APPROVAL FOR CONSTRUCTION

THE PLANS AND SPECIFICATIONS FOR SEWAGE OR WASTE DISPOSAL SYSTEM SUBMITTED FOR:

SCOTT WADLEIGH
PO BOX 3178
NORTH CONWAY, NH 03860

Subject: Wadleigh, Chatham

LOCATION SKETCH

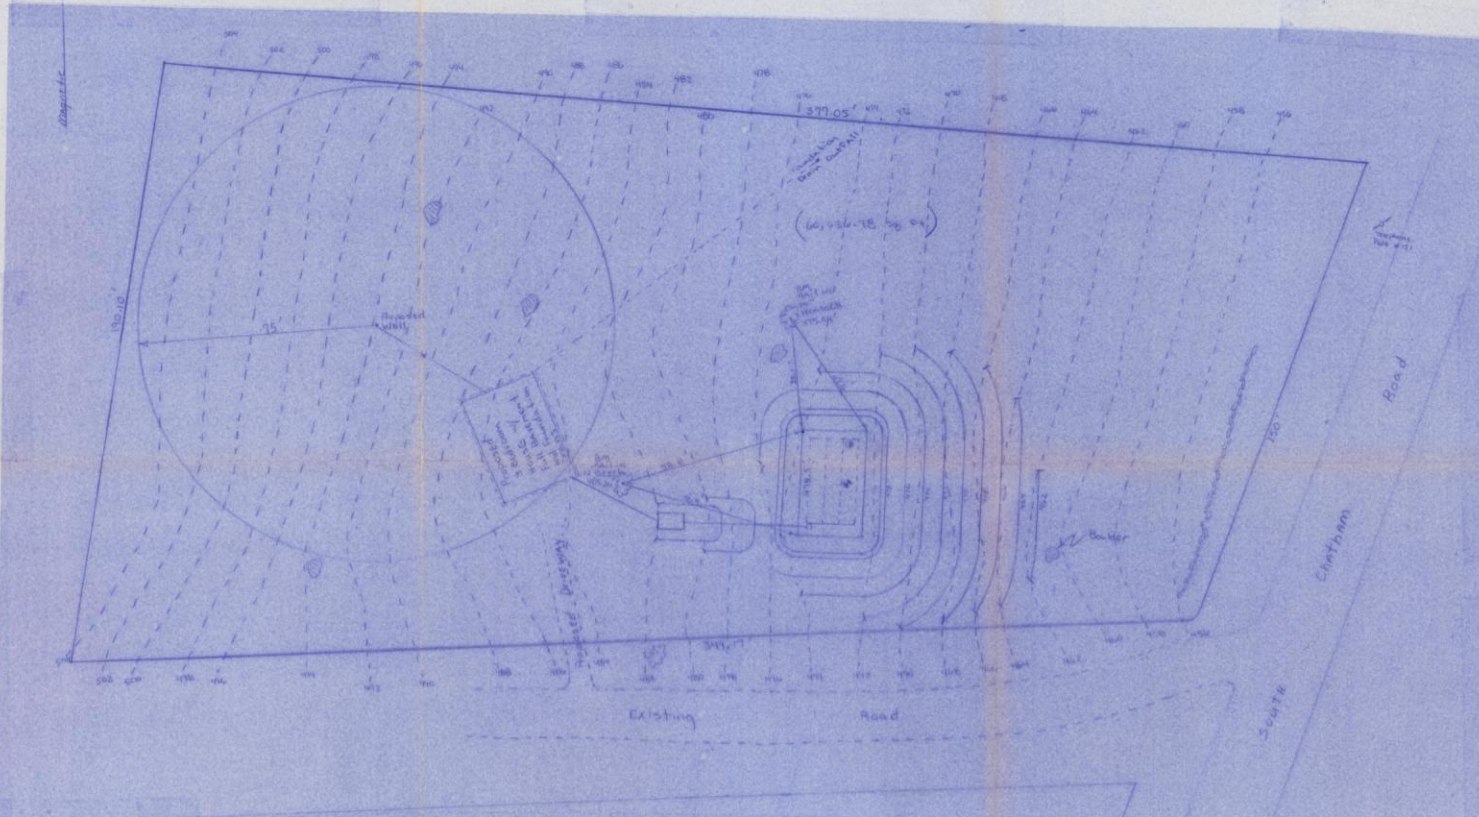
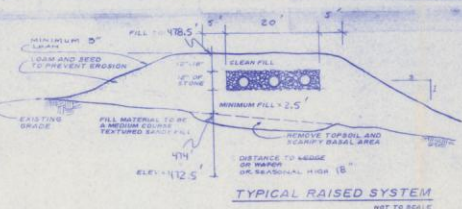
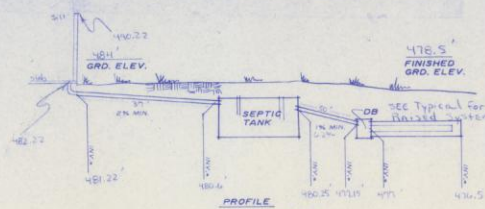
1. ✓ Each line into the bed must exit separately from the D-box, no tee's or ell's allowed.
2. Pending a site check to verify SHWT and site conditions.
3. ✓ Please show a major road on your locus map or provide written directions to South Chatham Road.
4. ✓ Lot number?
